MONUMENT RIDGE EAST FILING NO. 1
WATER, SANITARY SEWER, AND SANITARY SEWER FORCE MAIN
PLAN & PROFILES
EL PASO COUNTY, COLORADO

UTILITY CONSTRUCTION DRAWINGS

UTILITY SERVICE PLAN

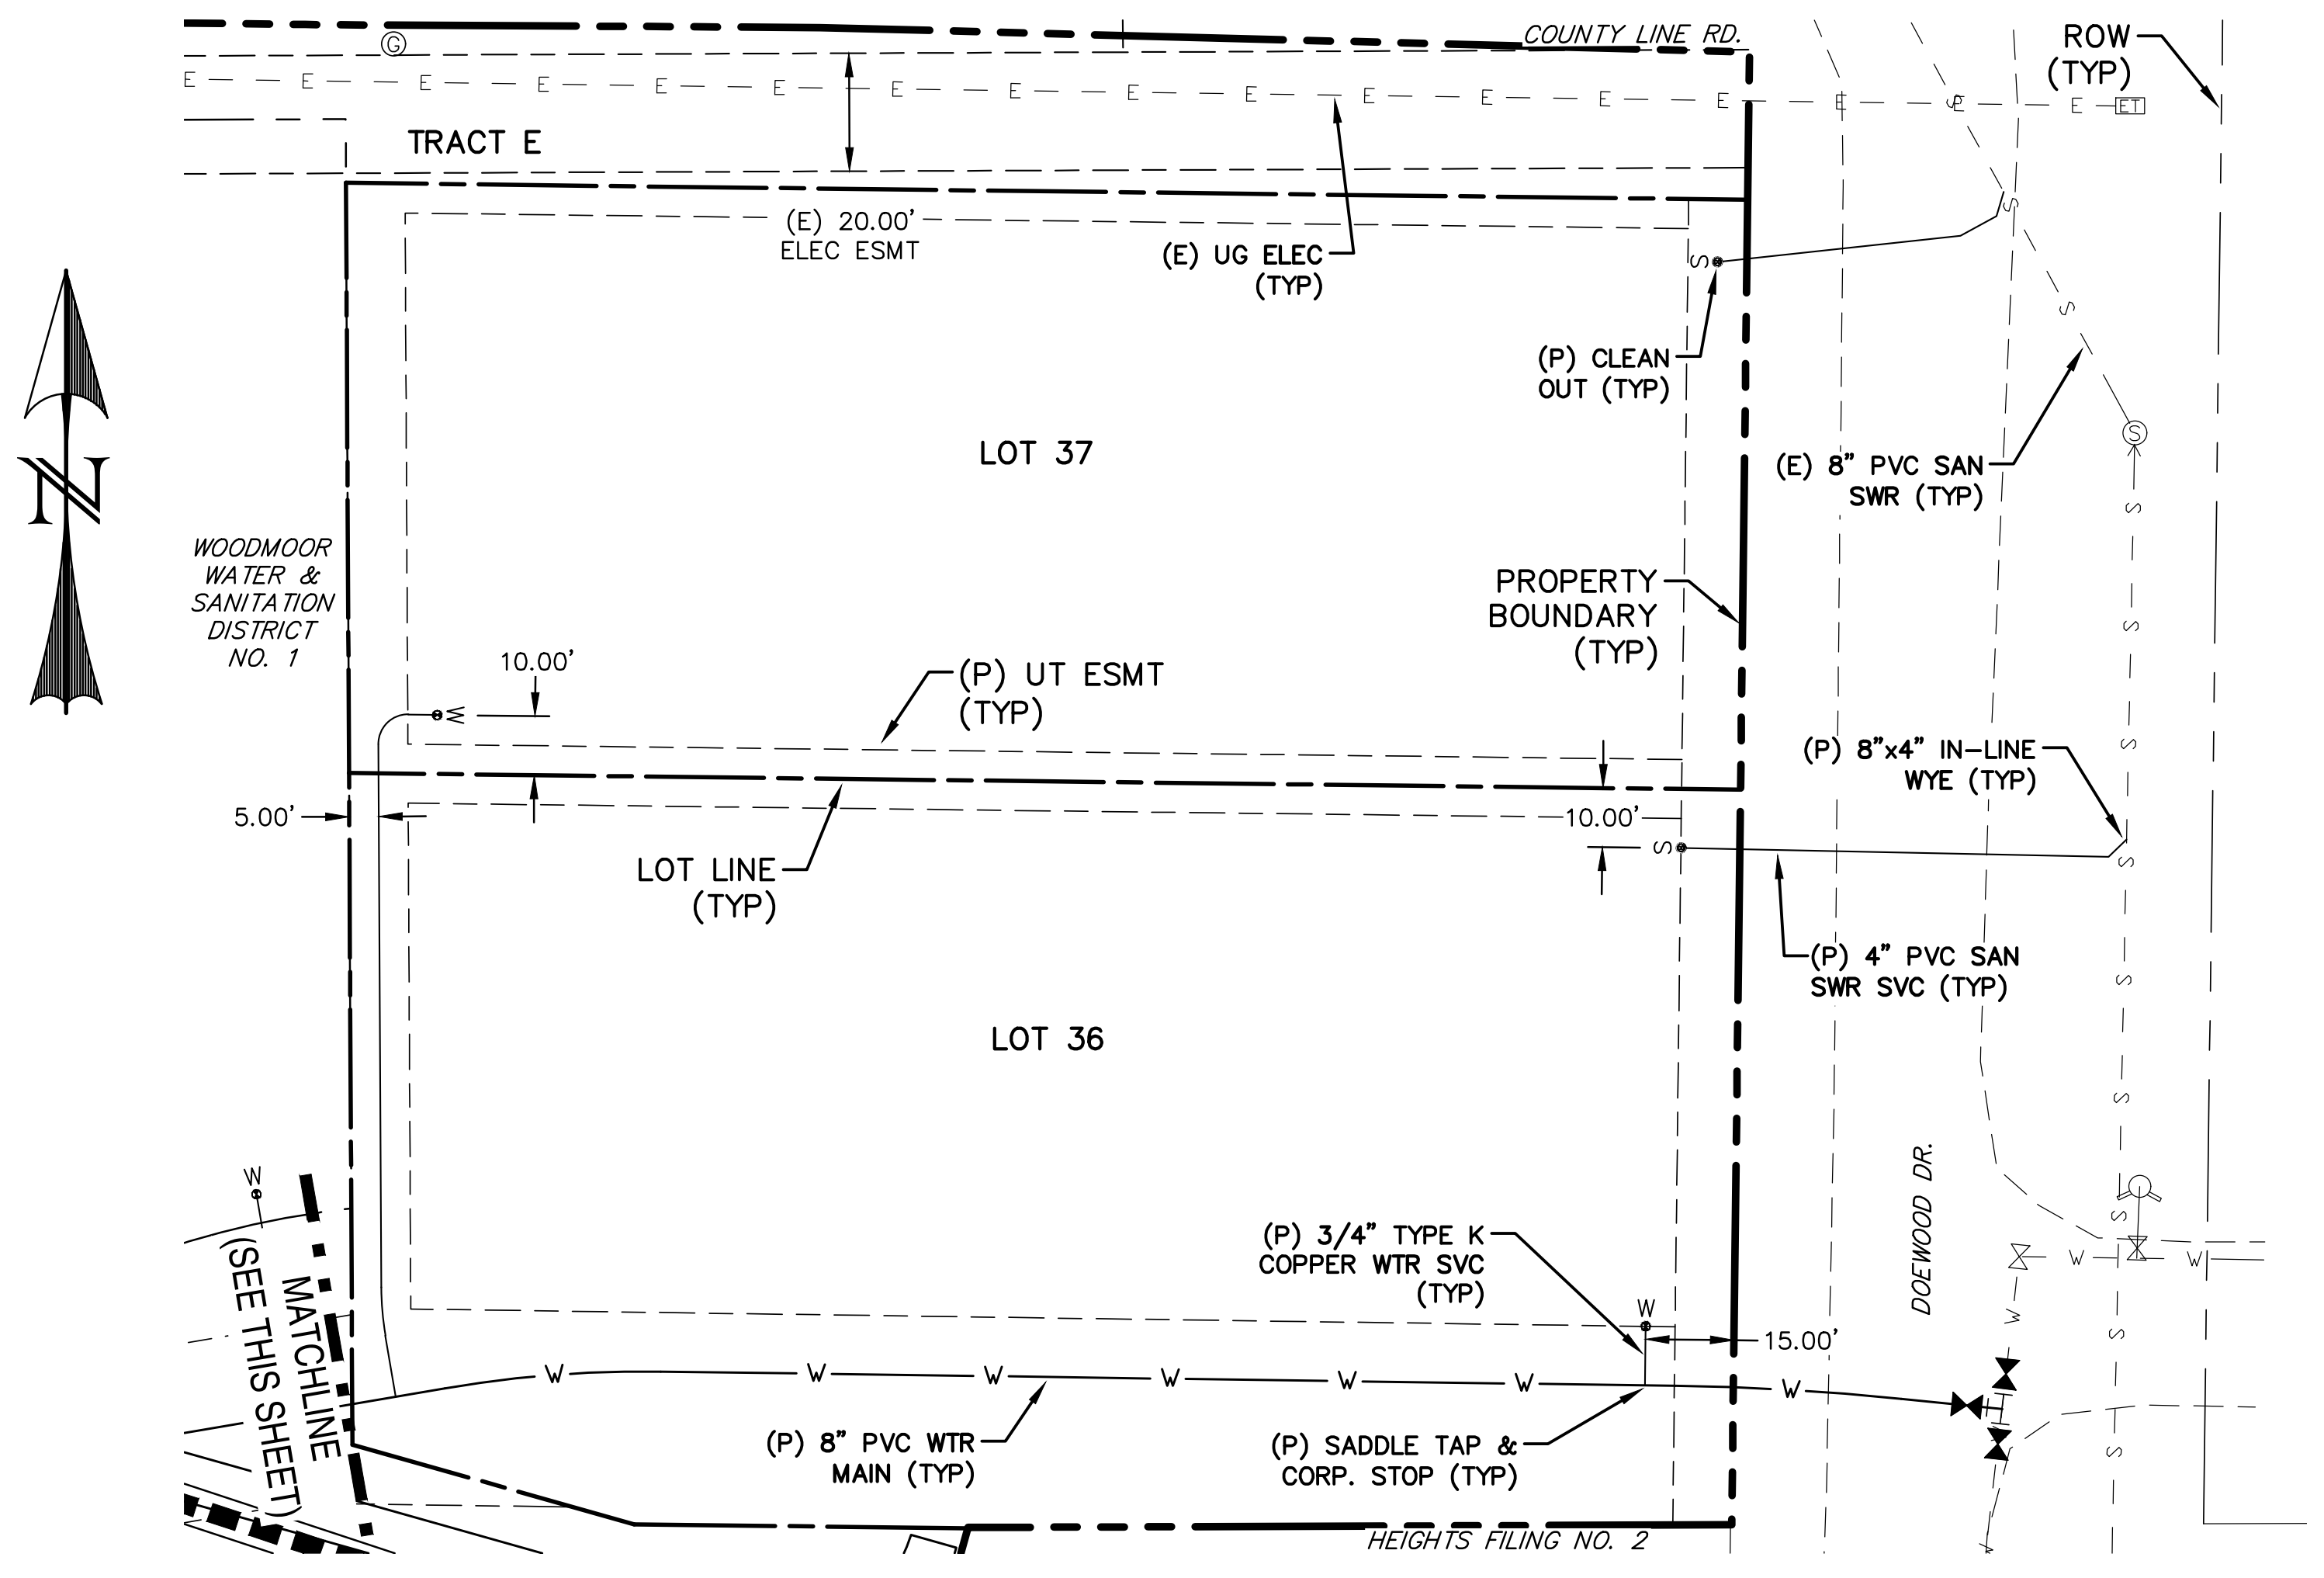
Provide details for outfall, size of riprap, dimensions of pad, where is underdrain in relation to riprap, etc
